CERTIFICATE OF APPROPRIATENESS

Property: 619 Woodland Street, Tracts 11 & 12A, Block 28, Woodland Heights Subdivision. The property includes a historic 1,182 square foot, one-story wood frame single-family residence and a detached garage situated on a 5,000 square foot (50' x 100') interior lot.

Proposal: Alteration – Construct a rear one-story, 61 square foot side addition and a 618 square foot second story addition to a one-story residence.

HAHC Action: Approved

EAST SIDE ELEVATION

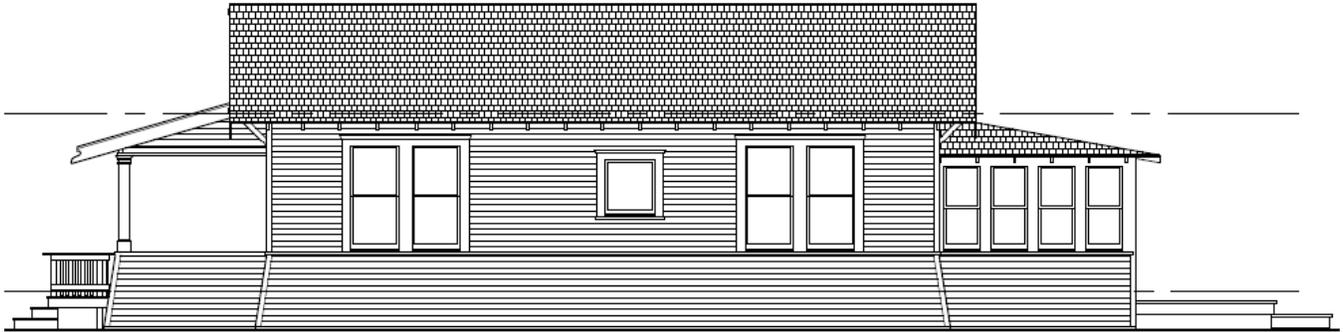
Side Elevation: A ribbon of four 1-over-1 sash windows will be raised so the window headers will be in line with the other existing window headers on the east elevation.
(East)

NORTH (REAR) ELEVATION

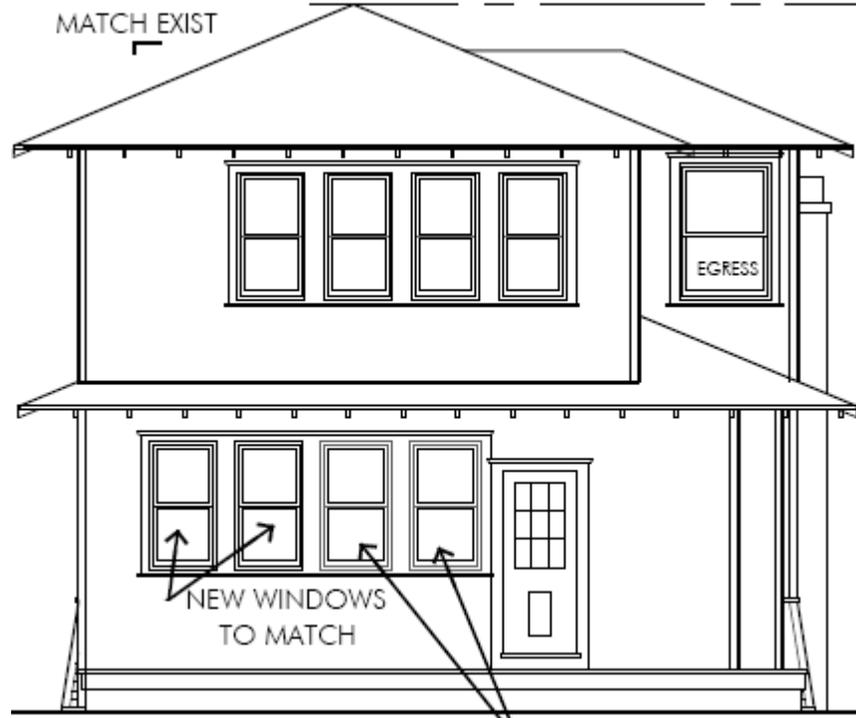
Rear Elevation: A non-original divided lite french door with divide lite side lites will be replaced with two 1-over-1 sash windows and two existing 1-over-1 sash windows will be relocated on the rear elevation to create a ribbon of four 1-over-1 sash windows.
(North)
